Thursday, June 4, 2020

This addendum is provided to all known prospective proposers for clarification of the subject Request for Proposal (RFP).

The following are questions received prior to the deadline for questions on Friday, May 29, 2020, at 5:00 PM (PDT) and the responses from VVTA Staff:

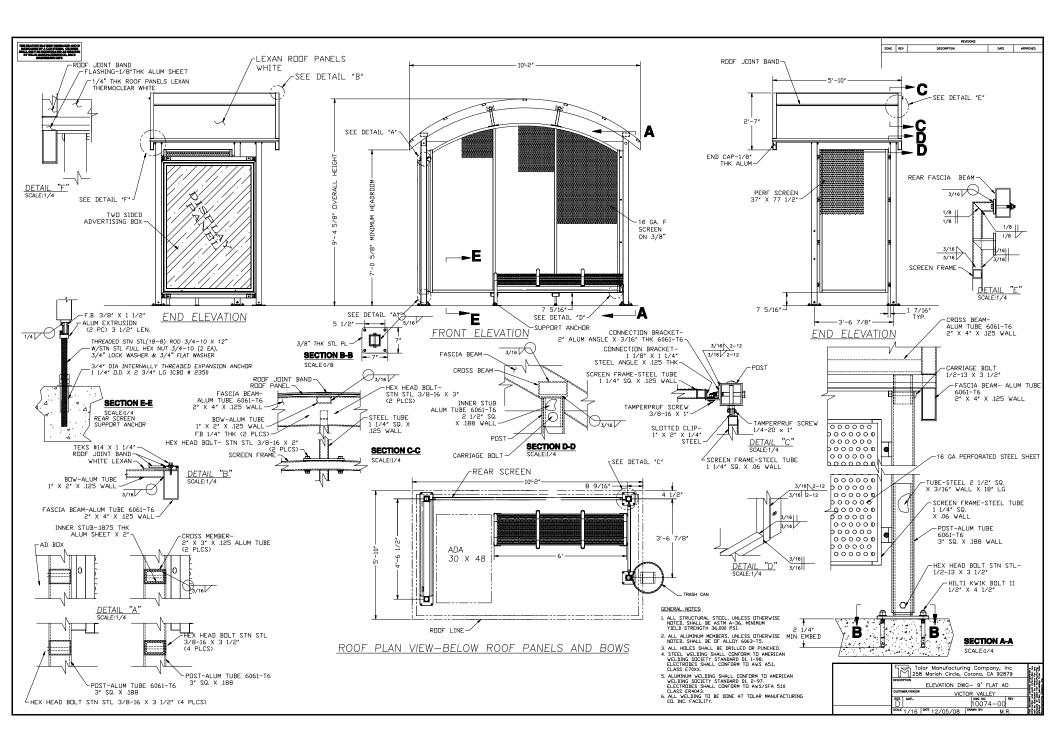
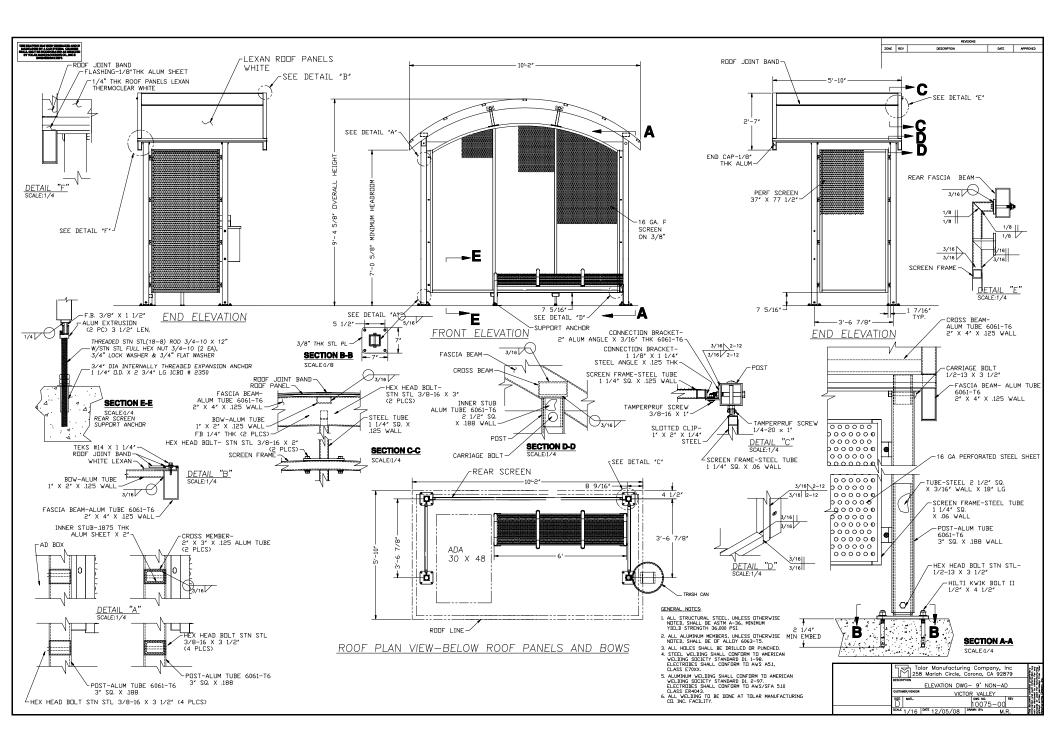
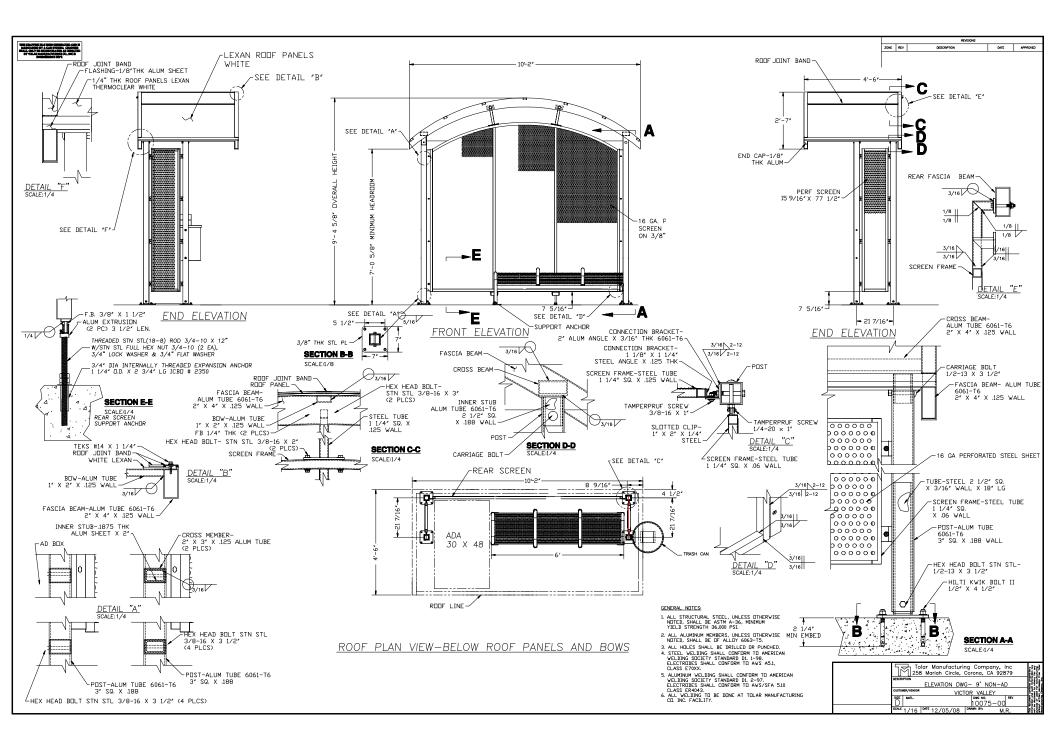
- A15: Please review the specifications.
- Q16: "Do you have specs or drawings?"
- A16: Drawings and pictures are included with this addendum.
- Q17: "The bid sheet, Attachment F pages 3 and 4, lists estimated quantities. Does VVTA have an estimate regarding how many of each item they may purchase at a time? These items, in most cases, are made to order and the costs to build one unit is
